P24/S1336/FUL – Land North-West of Nuneham Courtney, Oxfordshire

I am writing with regards planning application P24/S1336/FUL in relation to the ecological comments provided by Edward Church, Senior Ecology Officer for South Oxfordshire and Vale of White Horse District Councils, on 10th June 2024. Further clarification has been provided on the various comments under the relevant subheadings here:

Figure 1: Baseline Habitats Maps with Target Notes

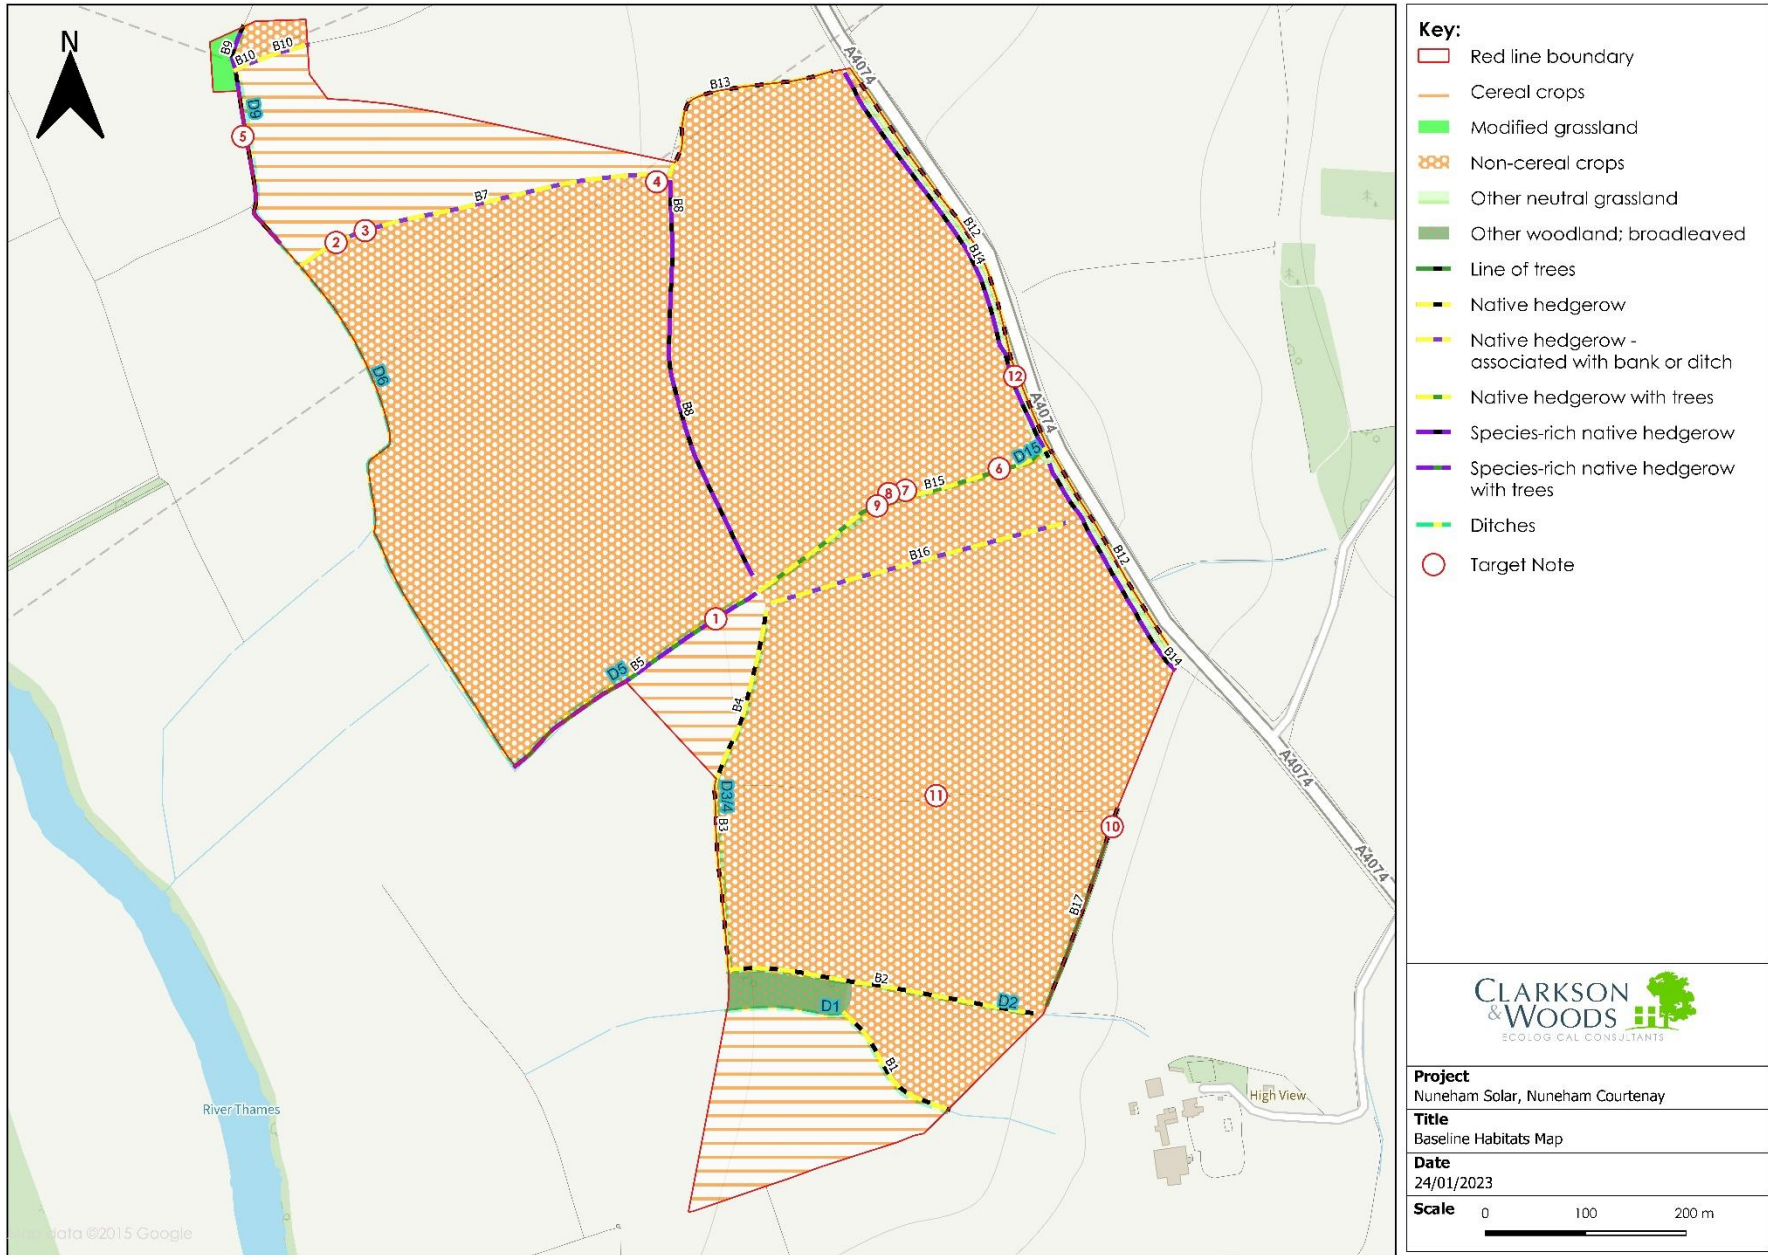
The locations of Target Notes were erroneously not included within the Ecological Baseline Report. A version of the Baseline Habitats map with Target Notes included is provided in Figure 1 below, with corresponding descriptions in Table 1. In addition, a map of badger setts recorded at the site, together with suitable protective buffer zones described within the ES, are provided in Figure 2. At present the setts can be retained and buffer zones accommodated under current plans, with no requirement to temporarily or permanently exclude setts under licence.

Figure 3: Proposed Skylark Mitigation Area

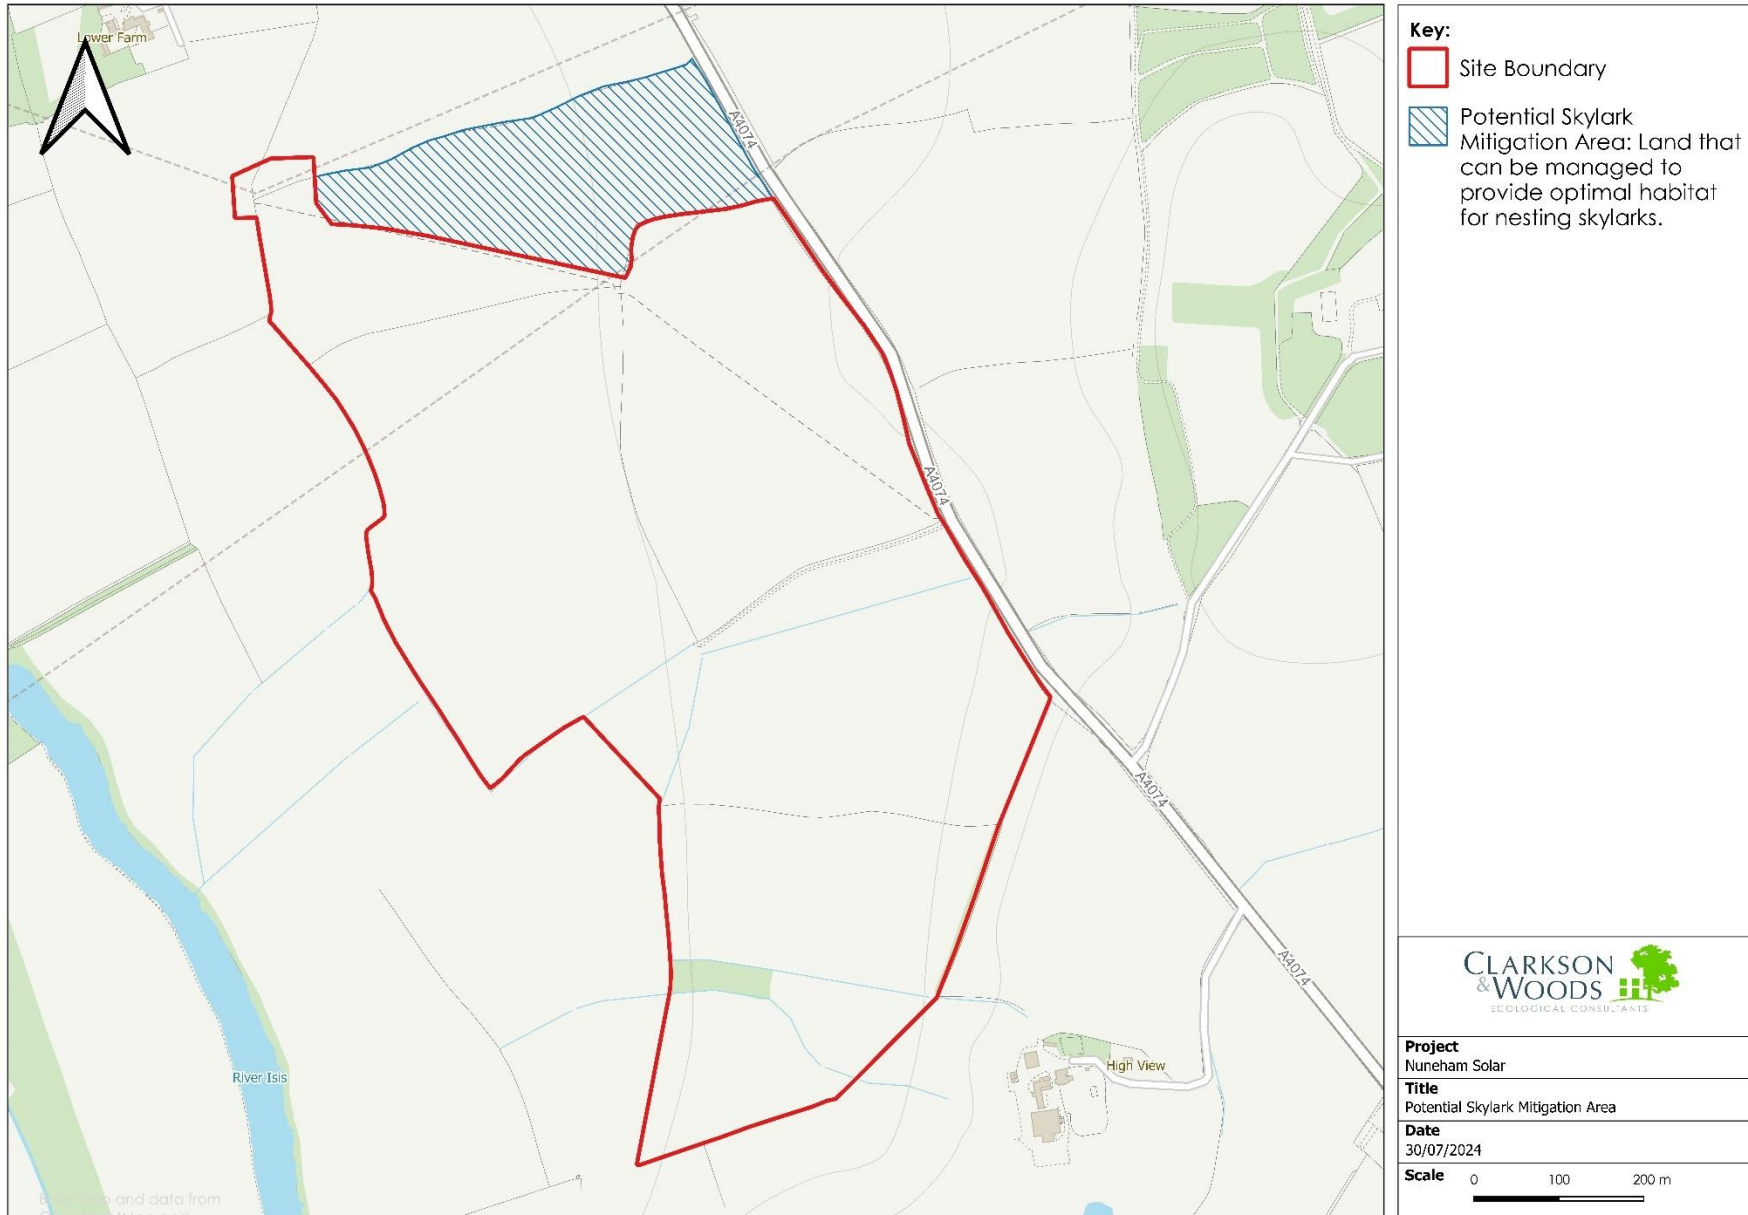
Whilst the ES concludes that the onsite mitigation measures would mitigate adverse effects on skylarks (and thus could be considered in line with Policy ENV2 of the South Oxfordshire Local Plan) consideration has been given to providing additional compensation off-site in light of the Officer's comments. Following discussion with the client, an area measuring approximately 8.85 hectares adjacent to the north of the site is potentially available for skylark compensation habitat. This area is shown in Figure 3 below. This land lies within the control of the application and falls within the blue line boundary as shown on the submission plan 'Figure 1 – Site Location Plan (Drawing Number 04531-RES-LAY-DR-PT-001)'. This is an area of arable land that was subject to breeding bird surveys during 2022 at the same time as the application site, and between 1 and 2 skylark territories were recorded here at a density of between 0.11 and 0.23 per hectare as shown in Appendix 7.1 of the ES.

This area can be enhanced for skylarks by through adopting sympathetic management which would provide optimal vegetation height and structure for skylarks to nest in. This can be in the form of several of habitat types, such as diverse grassland which is subject to infrequent and sensitively timed cutting, or through the land being laid to set-aside. Under such as regime, it is likely that the land could support a density of territories at the upper range of densities found on lowland farmland (0.5 pairs per hectare), or 4 to 5 pairs. It is considered that provision of such compensatory habitat, in combination with the previously discussed increase in foraging opportunities, would certainly adequately compensate for impacts on skylarks ensure Policy ENV2 is satisfied.

Although for South Oxfordshire District Council to ultimately decide, it is recommended that an appropriate Skylark Mitigation Strategy is prepared and agreed by way of a pre-commencement planning condition. Clarkson and Woods are happy to provide examples of where the provision of Skylark Mitigation Strategies have been the subject of a suitably worded planning condition on other solar array sites.
